Fort Chambers / Poor Farm Project

Engagement Window 4: Public Feedback Results

'Sod' and wooden pole material choices

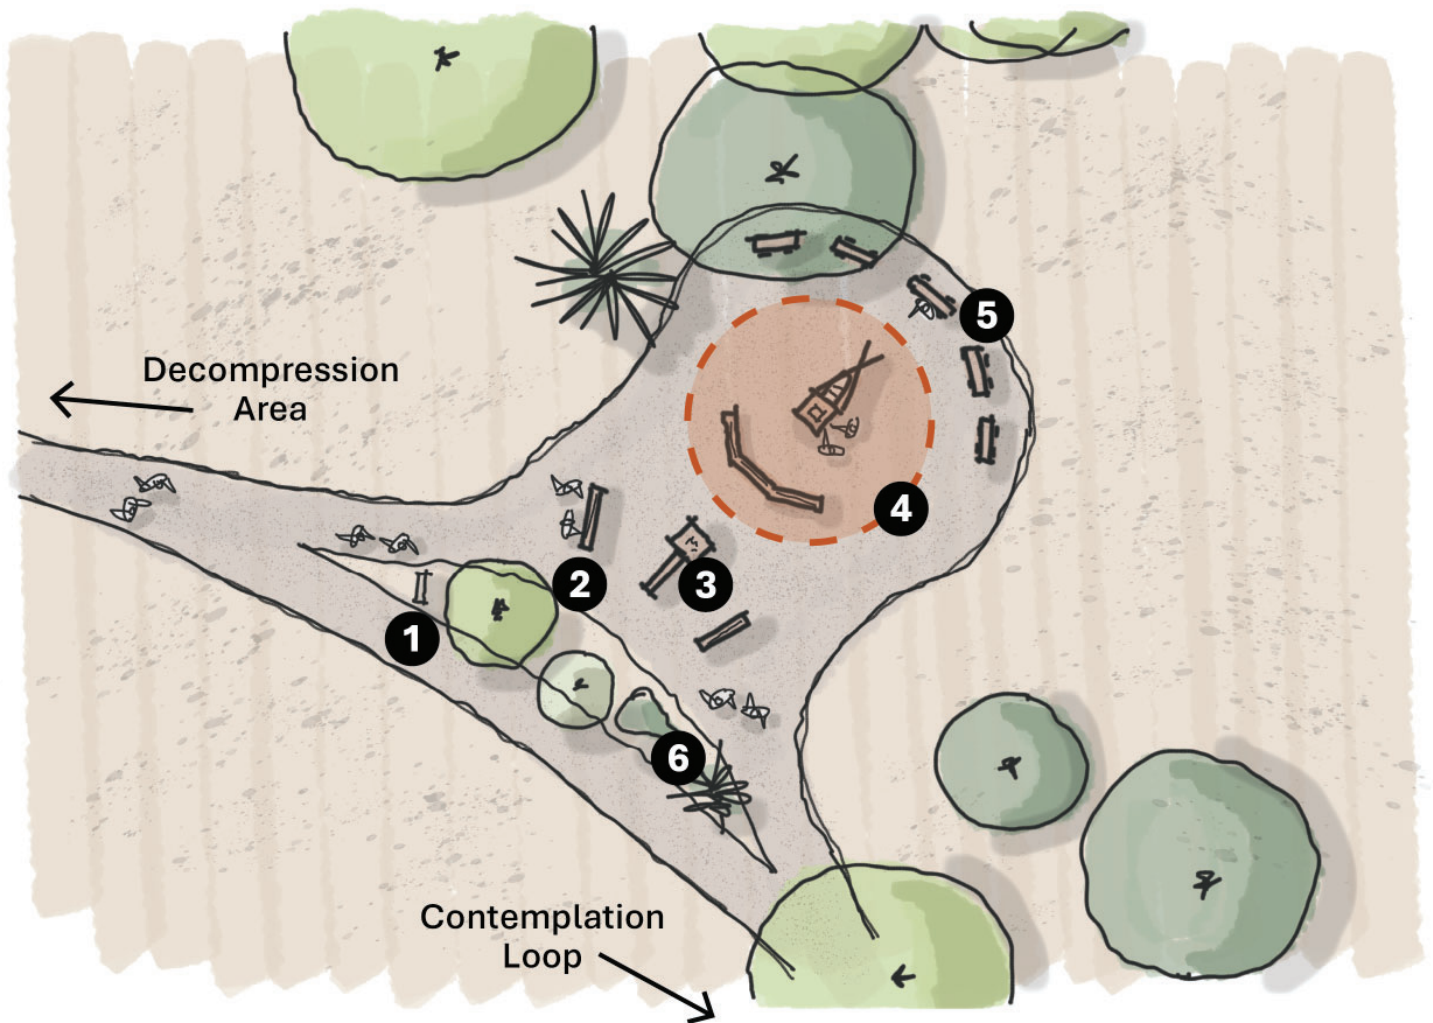
"Sticks (poles) – I can't imagine a more stereotypical depiction of the Indian people who governed and occupied the land. The questionnaire suggests they depict "Native American structures" – ahh tepees – and ingenuity. Beyond tepees what "ingenuity" is depicted?"

"The image of a bunch of poles representing the Arapaho and Cheyenne people is offensive (harkens back to the "wooden Indian" stereotype)."

Q6. Design 1: Angled Marker

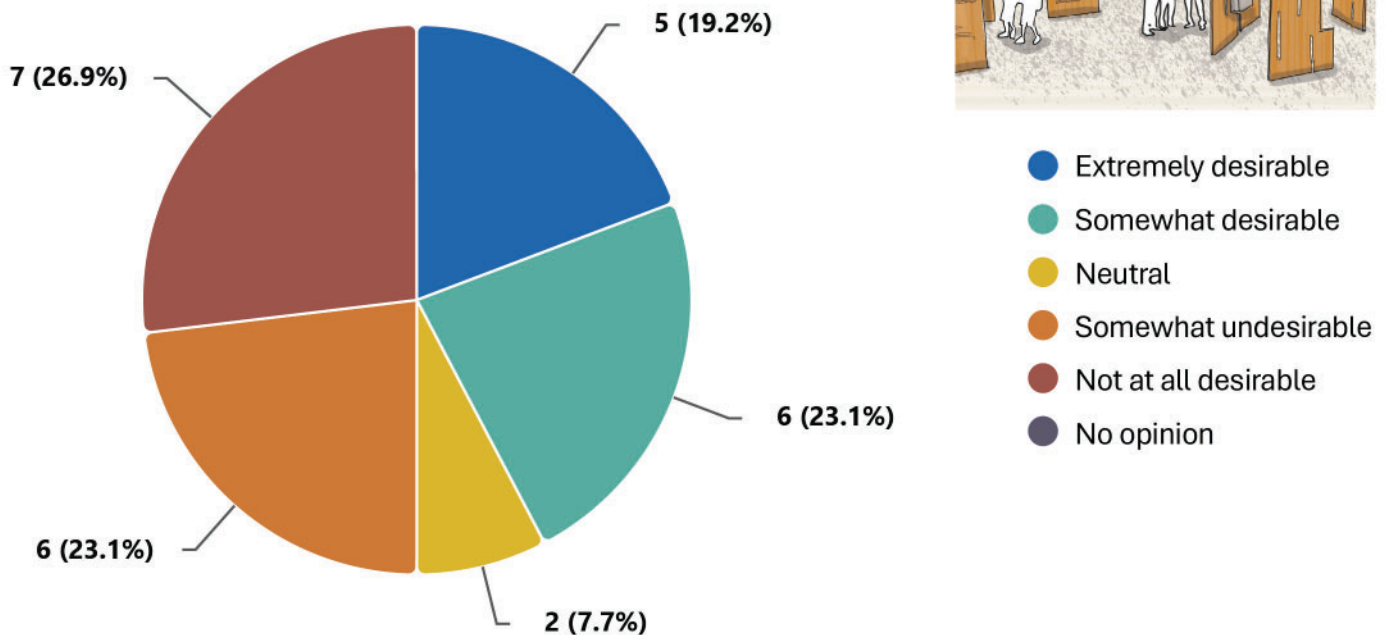
“I like the “shift” of the marker from its traditional vertical orientation. By removing it from its original position it maintains the history of the object while also indicating that message is a relic of what WAS, not the current thoughts/feelings about this site.”

“The angled original marker does not “[suggest] a shift in how its inscription is understood today.” It reinforces the centrality of this view, even today.”

“The marker is not sitting upright as it originally was placed. The marker is therefore not viewed as intended. The marker is disrespectfully placed.”

“I like how the original marker is treated so reverently.”

“Shielded marker, allows visitors to enter at own pace with different depths to the experience.”

“the use of the same sod and poles from the decompression area resonate with me... the repetition of the sod and poles gives the space some continuity”

“the use of the sod and poles is a little bit strange here, since they represent indigenous and settler perspectives. I don’t believe they were unified over this marker, and having the strongest use of these materials in this way at the marker feels off..”

Q9. Design 2: Framed Marker

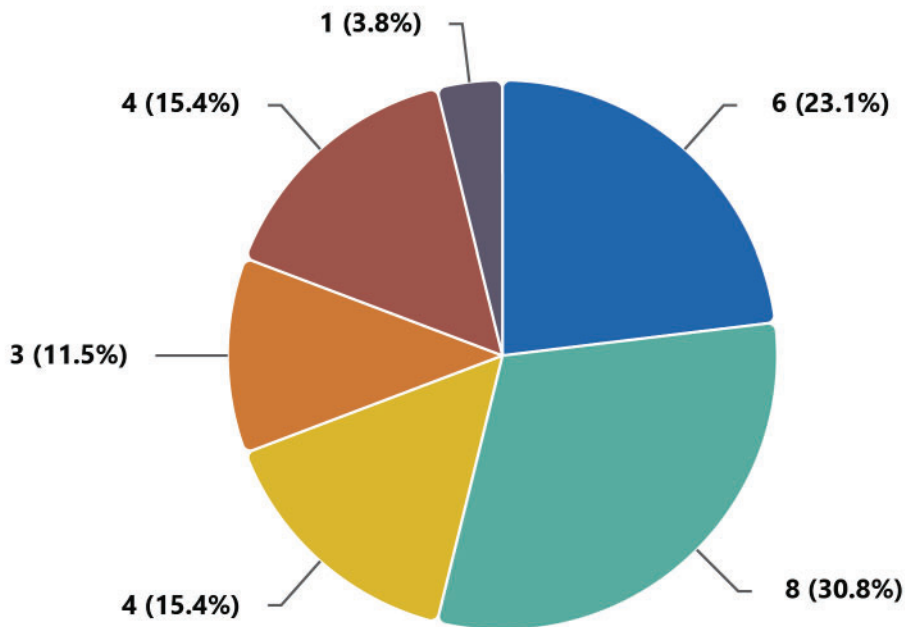
“No 2 marker frame. This is an excellent way to present the history.”

“Depending on the accompanying text, the marker placement suggesting framing and holding layered histories is an improvement.”

“The 1800 pound marker was not created to be off the ground between two panels. This display is misleading and not historically accurate.”

“I like the usage of materials that will change over time.”

“Rusting metal and passage of time seems to ISOLATE the event from the present, make it just something of the past, reduces its contemporary relevance. I don’t like that at all.”

“So we go from silly sticks idea for Native Americans to the opposite -- a bunch of rusting metal that doesn’t reflect any Native cultural or design elements.”

Q12. Design 3: Cardinal Directions

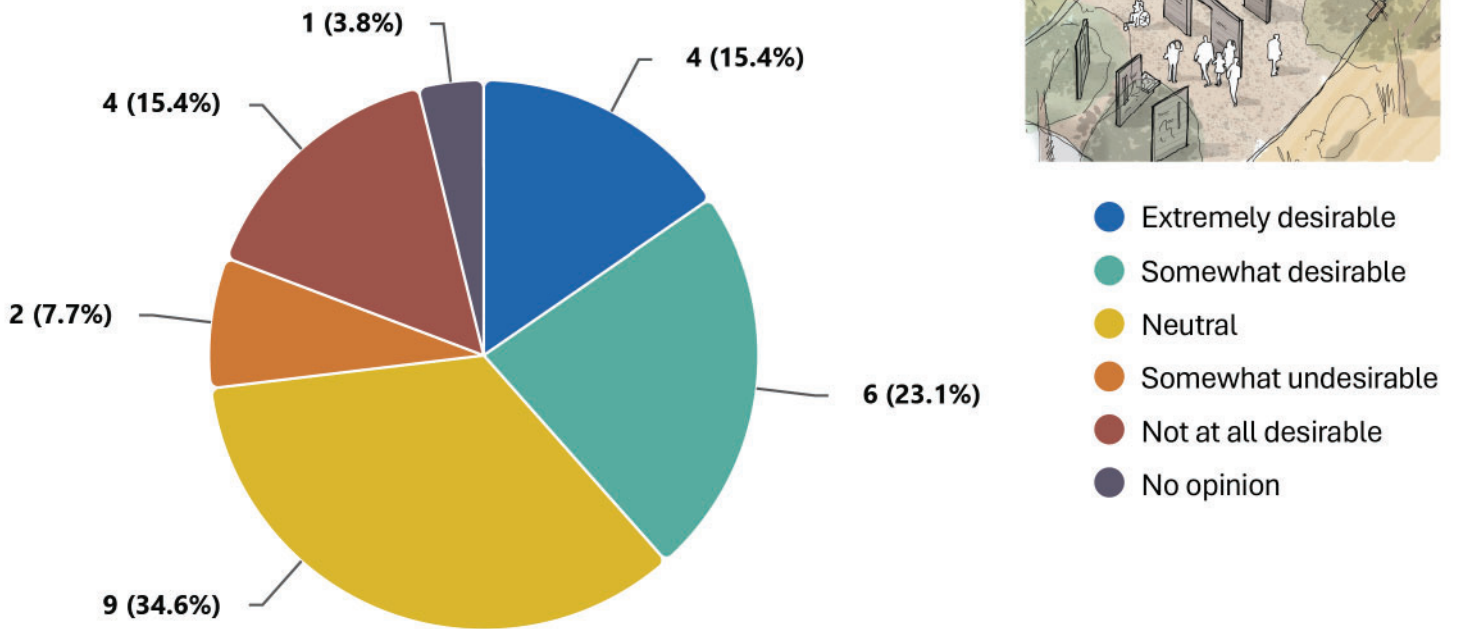
“Being able to wander through different panels and around the marker is appreciated. I’d like to be able to move through the space, instead of having to stand still and read.”

“While the marker is circled by panels that provide context and different views, it feels uncomfortable to me to have it be the center element in this circular formation.”

“The cardinal directions which are central to Tribal traditions. This design pays respect to those concepts. The open design is also helpful”

“the idea of a sundial and the possibility of introducing Native interpretation via a medicine wheel appeals to me”

“It’s hard to include Indigenous elements (sundial, cardinal directions) in this area where we need to focus on what happened at the fort and at Sand Creek and afterward. Maybe it could work as a subtle reminder that Native people were here and their cultures continued throughout this horrible time. If the Arapaho and Cheyenne representatives like this idea, that’s important.”

“The potential use of a medicine wheel seems gratuitous and to be cultural appropriation; such use needs sufficient context for the religious and spiritual aspects of the medicine wheel. The medicine wheel is principally an experience. It’s presence here could be that, but the text shows no indication that would happen.”

“...slabs similar to the marker? Why?”

Q15. Design 4: Passages

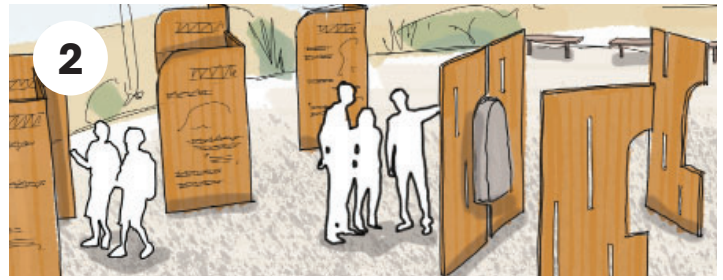
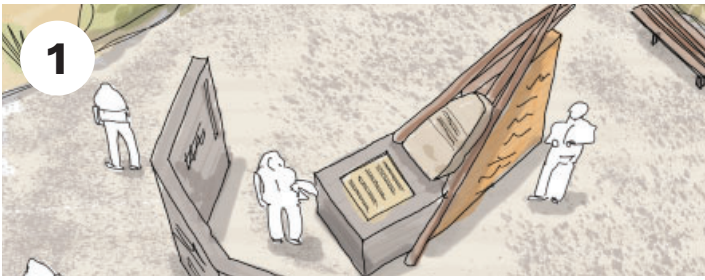
“There is an appeal in moving through doors of understanding perhaps here allowing various perspectives from the past and then moving into contemporary understandings. And perhaps murals on each “wall” around the door ... bringing history “to life” and color.”

“If the gateways tell the story in chronological order, that is useful. I like the last gateway opening to reflection, as long as the reflection/contemplation area provides challenging questions about the meaning of this history for the people of Boulder today.”

“No 3. an exit view of the wetlands will be peaceful and provide some emotional relief after experiencing the quotes and other material”

“Gateway to what? Healing? For whom? Facing away? Looking at swamp lands? I don’t understand. I thought this would be about facing our past and having the truth presented so that we never do this again. Looking away will not help.”

“I like... that you are forced to go around the panels to read the inscription.”

“I appreciate the framing of the marker, similar to design 2. Also, there’s something metaphorical about framing the marker in new information and with reinterpretation that I like.”

“It’s a little unclear if you are or are not supposed to walk through the gate ways.”

“Too large and uninviting to this natural space.”
